CITY OF CONWAY, ARKANSAS HISTORIC DISTRICT COMMISSION

April 26, 2021 • 5:30pm • 1111 Main Street

819 Mitchell Street - New Single-Family Residence

HDC2021APR01 - Robinson Historic District

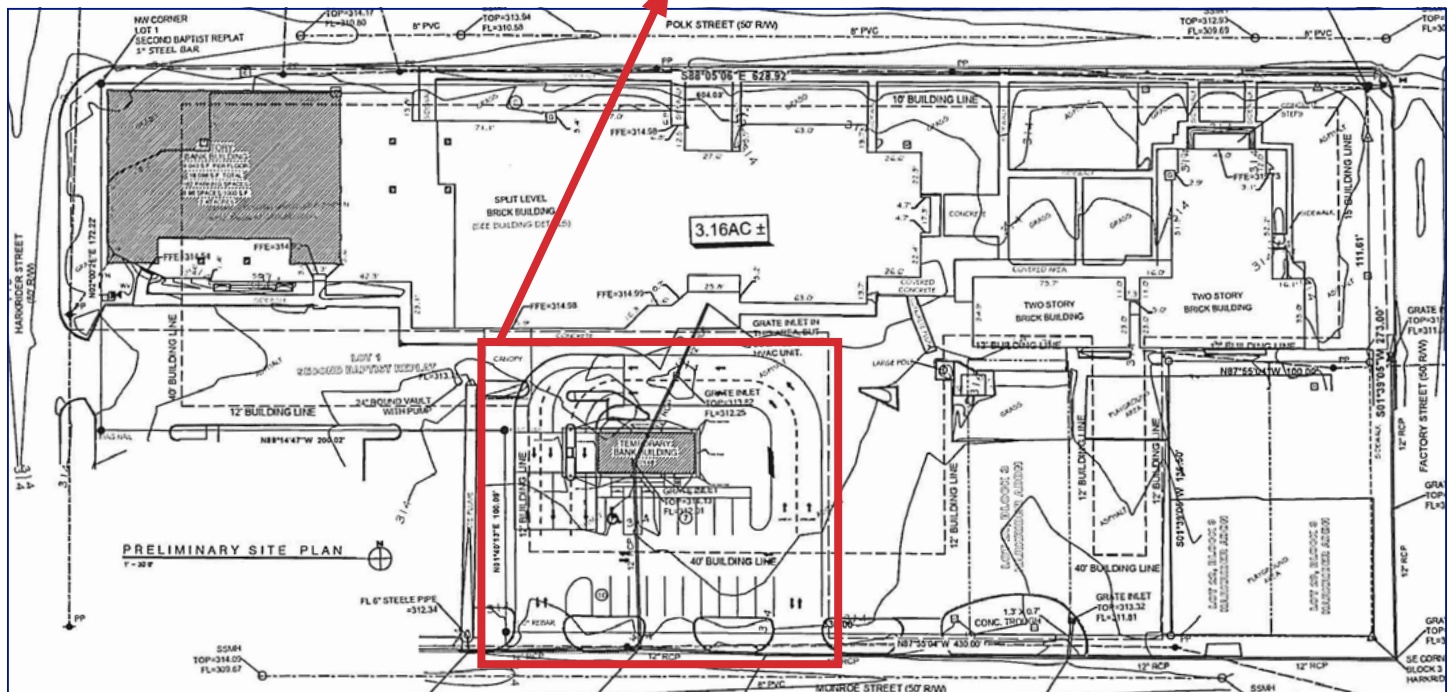
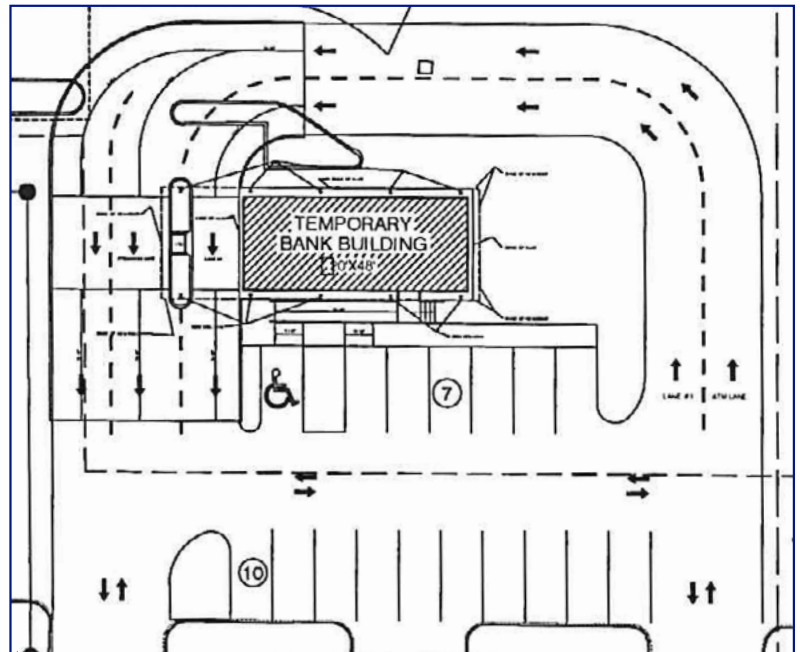
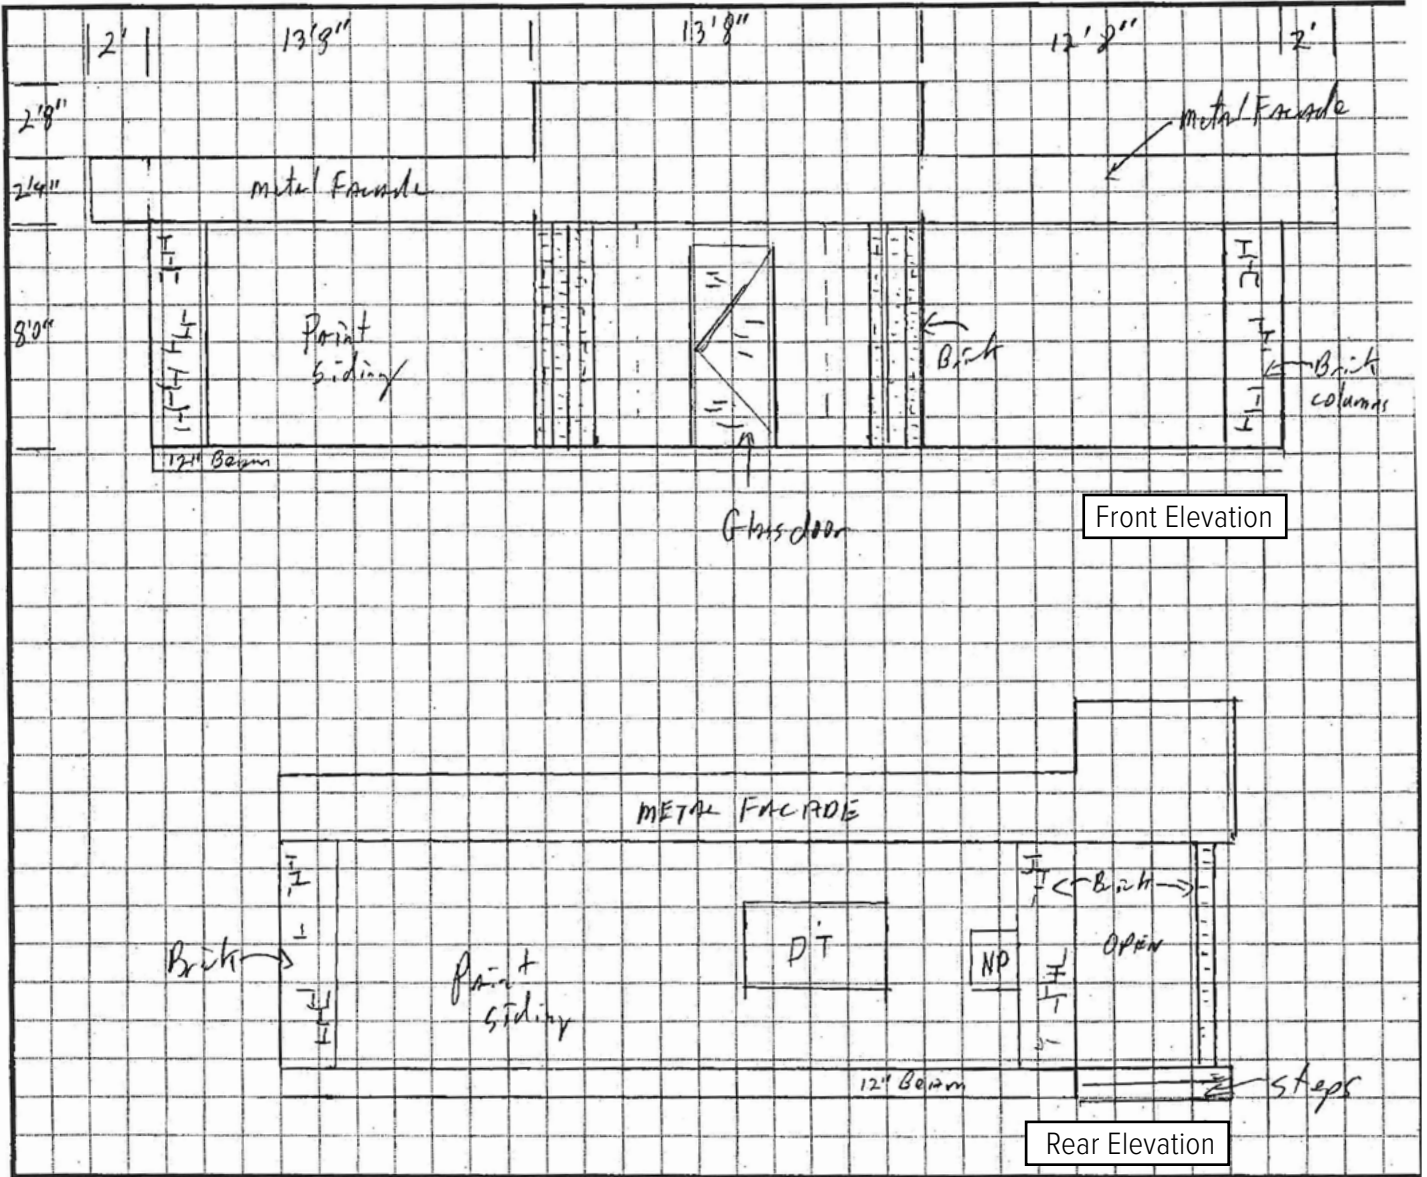
The proposed building is located beyond the required guideline setbacks, however given the temporary nature of the building, the proposed location is appropriate.

Given the temporary nature of the building, the proposed location is appropriate. The interim building will feature a drive-thru and ATM island on the west side of the building. The drive-thru lane will que along the rear of structure in an appropriate manner.

Façade, wall area, rhythm. As proposed, the front façade of the structure will not meet the standards of the Overlay District, however the proposed building is temporary and will be removed after a specified period of time.

Shutters, Roof, Decks/Plaza Space, Skylights, Mechanical Screening. The applicant is proposing a minimally sloped TPO roof. Given the nature of the temporary modular building the roofing material is acceptable. Recommend requiring that HVAC not be placed at the front of the building and be screened.

1. The building shall be removed prior to April 27, 2023.
2. The building shall comply with Development Review standards in accordance with Article 1101 of the Zoning Code with consideration given to the building's temporary nature.
3. Appropriate interim building permit shall be obtained from the Building Permits Department.
4. HVAC equipment be placed in a manner to minimize its visibility from the street. Landscape or equivalent screening may be required.
5. Additional landscaping shall be provided along Monroe St to adequately screen parking; no trees shall be removed as part of the project.
